Town of Parker Community Development Department  
 Development Review Division  
 Attention: **Stacey Nerger**

Application Type: **Minor Development Plat**  
 Status: **First Referral**  
 Application Name: **Lincoln Professional Park Filing No. 1 MDP**  
 Case/AP#: **SUB20-002**  
 Referral Received: September 22, 2021  
 Comments Due: October 20, 2021

Review date: **October 14, 2021**  
 Plan reviewer: **Randall L. Capra, [rcapra@parkeronline.org](mailto:rcapra@parkeronline.org)**  
 Phone: 303.805.3163

<b>TOWN OF PARKER</b>	<b>FIRE/LIFE SAFETY DIVISION:</b>	<b>R REVIEWED FOR CODE COMPLIANCE; REVISIONS REQUIRED</b>
-----------------------	-----------------------------------	---

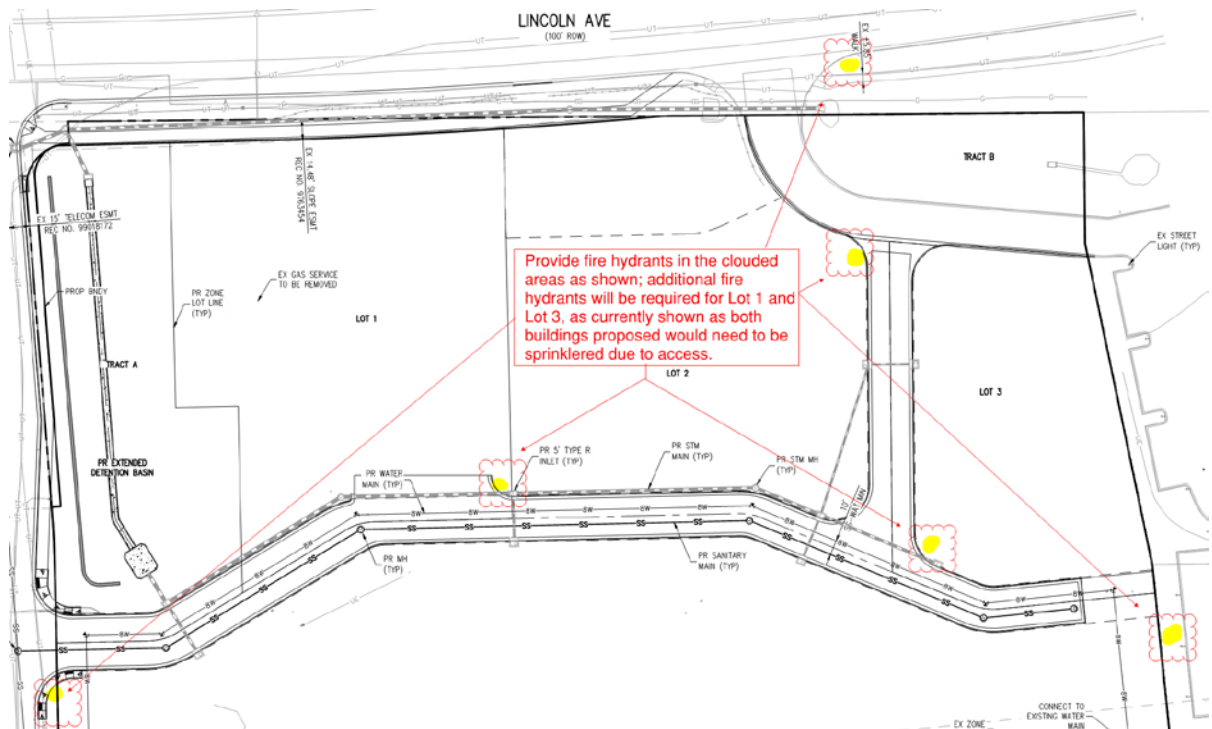
5.  The applicant shall provide an auto turn analysis indicating that apparatus can navigate all portions of this site; **NO PARKING – FIRE LANE** signage is required for any portion of the access where the 20-foot clear width

requirement cannot be met. Address this issue when resubmitting. Note - Information on South Metro Fire Rescue Apparatus has been provided at the end of this document.

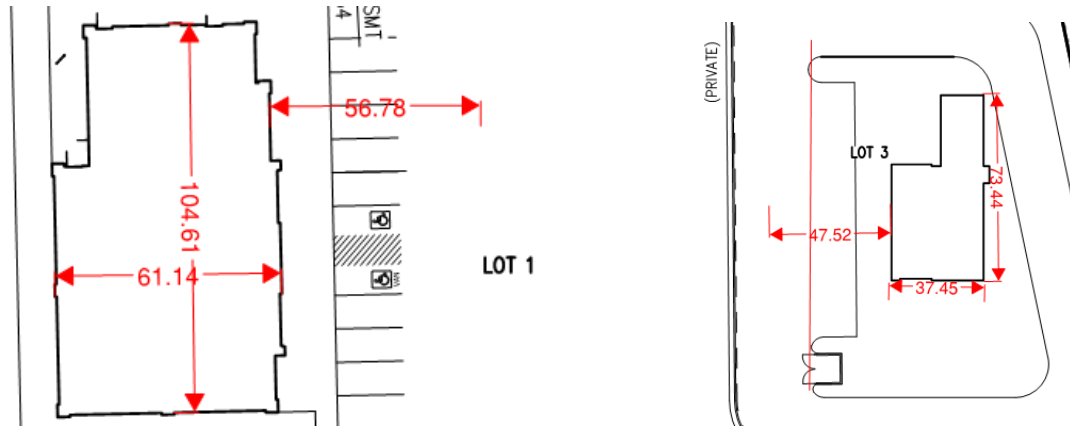
8. **Sheet 3 Overall Utility:** The overall utility drawings are incomplete; the plan set does not address fire hydrant locations for the spine roads proposed. The applicant shall address this issue and fire hydrants will be required in the following locations while noting that additional hydrants will be required on the internal lots depending upon access and use (the gas station will be required to be sprinklered as will Lot 3... as currently shown):

- The entry off of Dransfeldt Road on to Road A
- The entry off of Lincoln Ave and the current Private Drive
- Road A (required extension) into Lot 1 Filing No.2 Peaslee Subdivision at Road A and Lot 1
- At the corner of Road B and the Private Drive
- At the corner of Road A and Road B
- At the entry of the gas station off of Road A

See below for locations required:
